Safety Notice

SN640

Models Affected: General and TM

SUBJECT: Tie down weldments

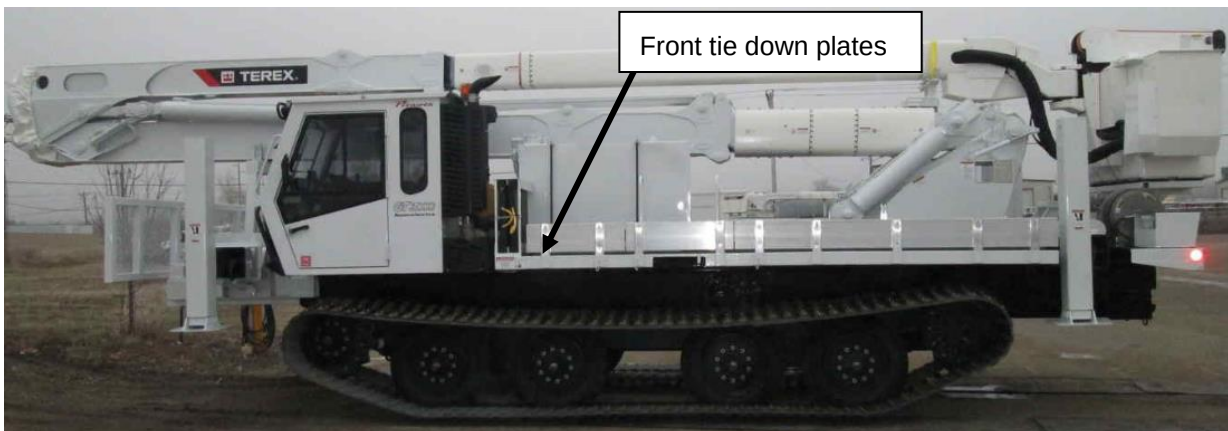
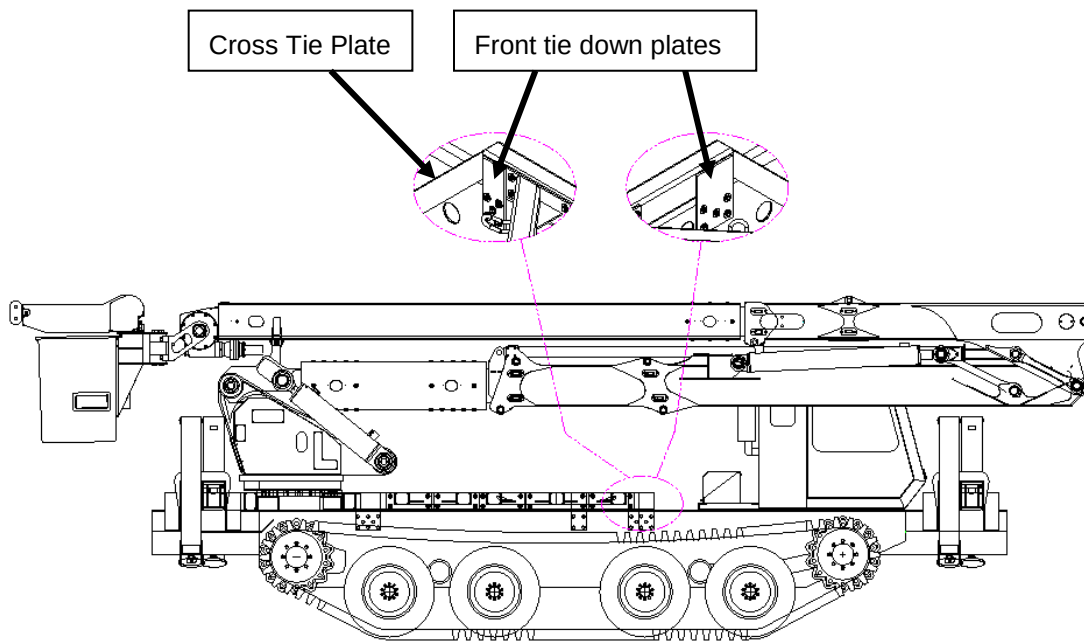
Terex has determined that some track mounted aerial and digger derrick devices manufactured from December 2005 through March 2016 may have subframe tie down plate welds which could crack. Twisting of the track frame by fully extending one outrigger at a time puts excessive stress in the tie down plate. **Failure of the subframe tie down plates could result in unexpected motion of the boom or the platform falling.**

1. Inspect each front tie down plate and its weld located behind the cab that joins the subframe to the track frame. Inspect the cross tie plate and its weld located behind the cab that joins the two subframe tubes together.

Terex will install a reinforcement kit, decal, and operator's manual supplement at no cost to the owner.
